GJS Plot F, Manchester

Non-material Amendment | 10.07.2024

Z1-SHP-A180-RP-XX-NMA02 | P01

Consented Scheme - F2-SHP-G200-PL-Grd-B5D801 - P02

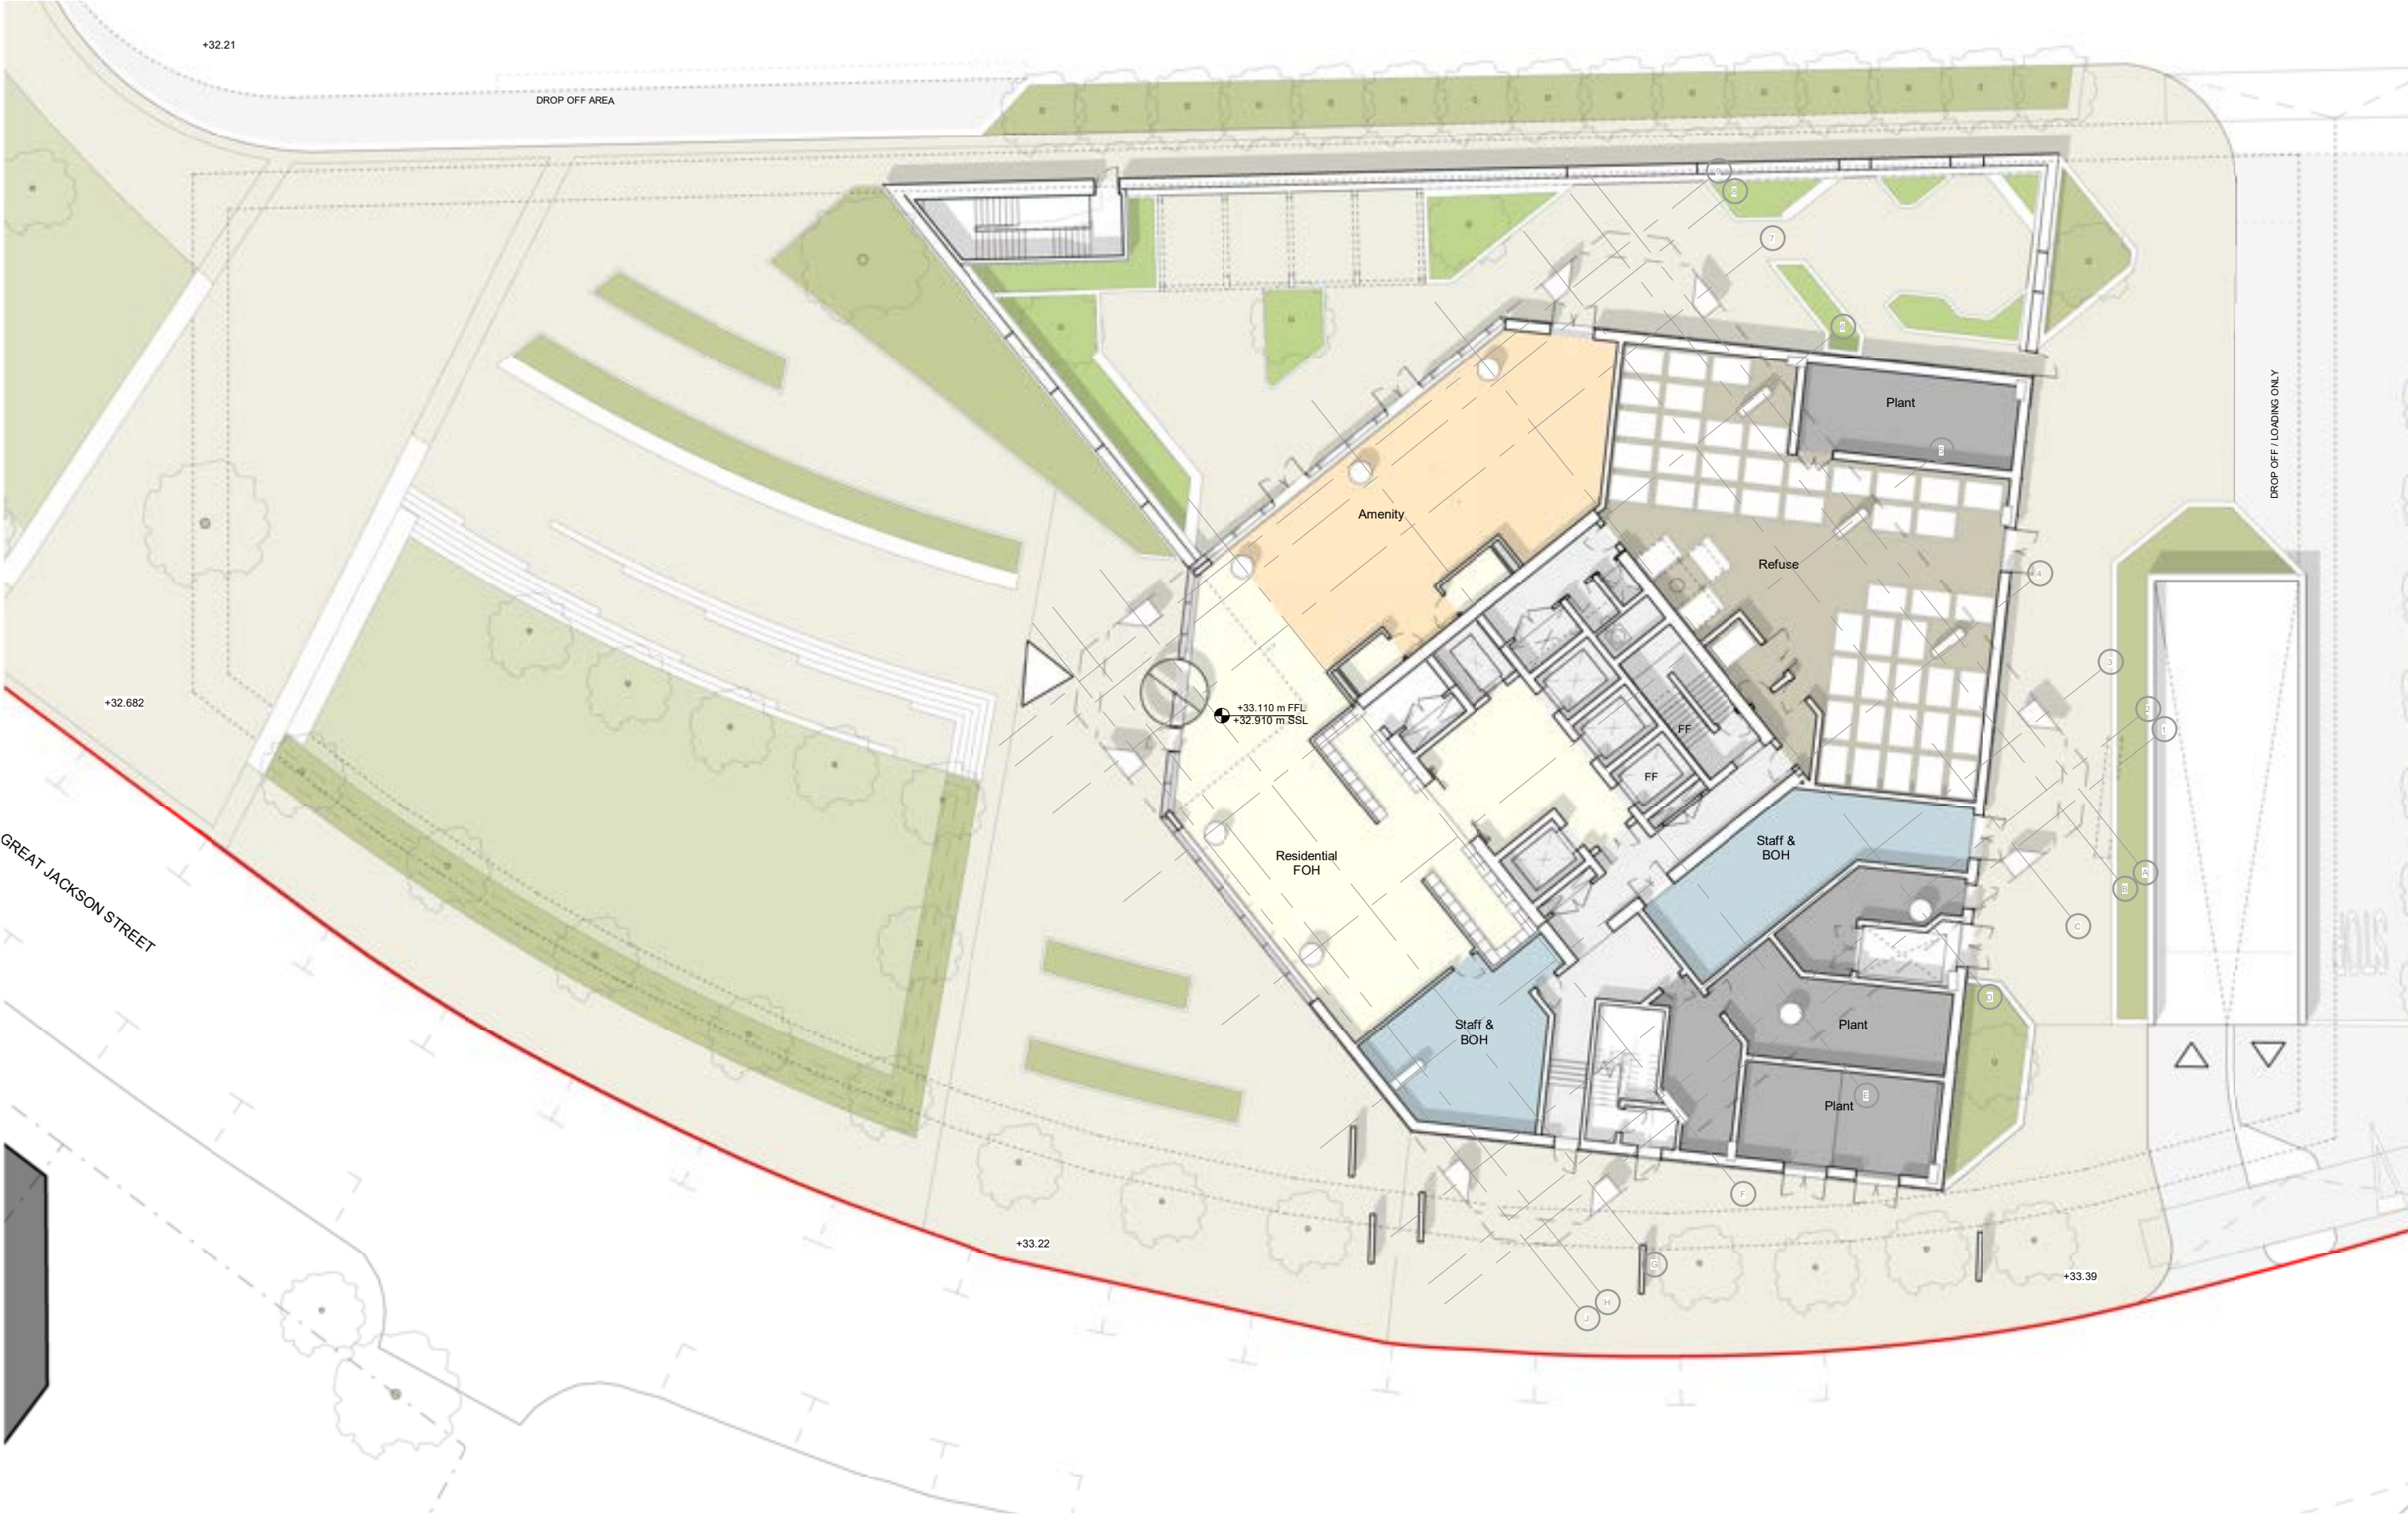
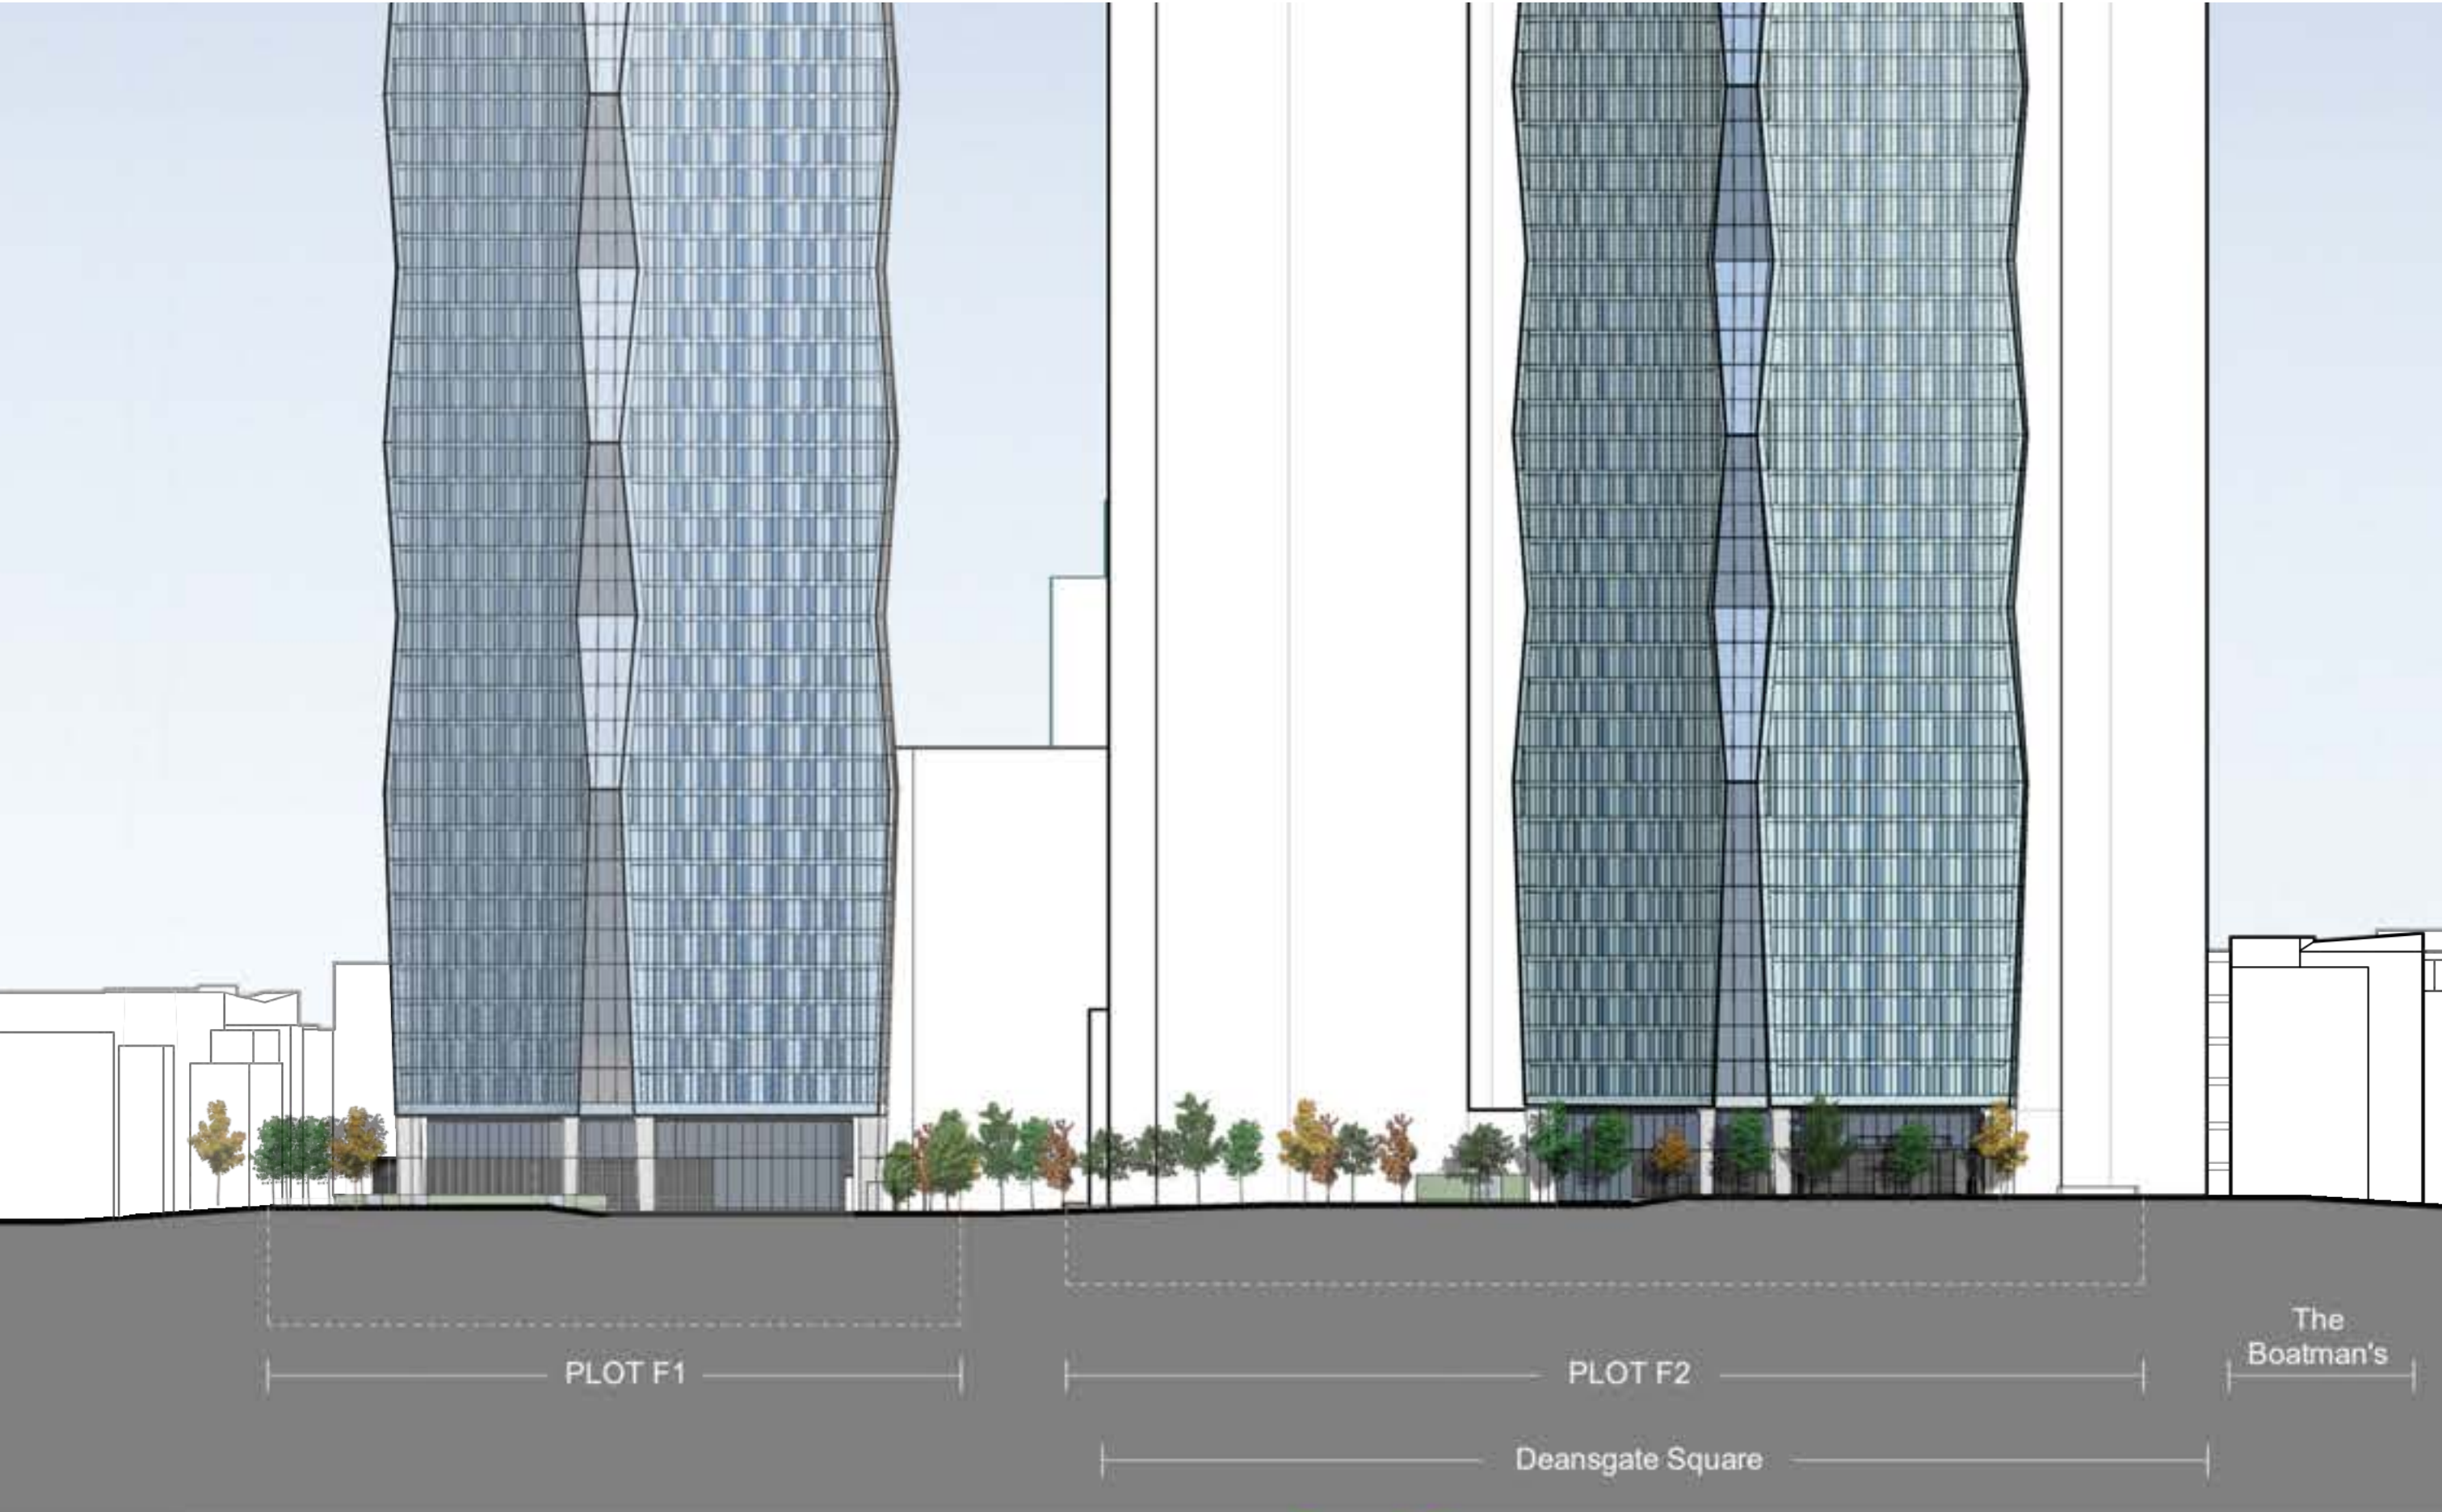
- c. **Tower F2 - Pond Street changes; raised boundary at the private garden and re configuration of the stair enclosure**
The landscape boundary treatment to the pond street elevation of F2 has been reconfigured, allowing a greater landscaping zone and wider footpath.

Additionally the standalone escape stair that forms part of the F2 garden wall has been reduced in length but increased in width slightly to accommodate a smoke extract shaft to the stair lobbies. The overall footprint is similar to that of the consented scheme.
3.
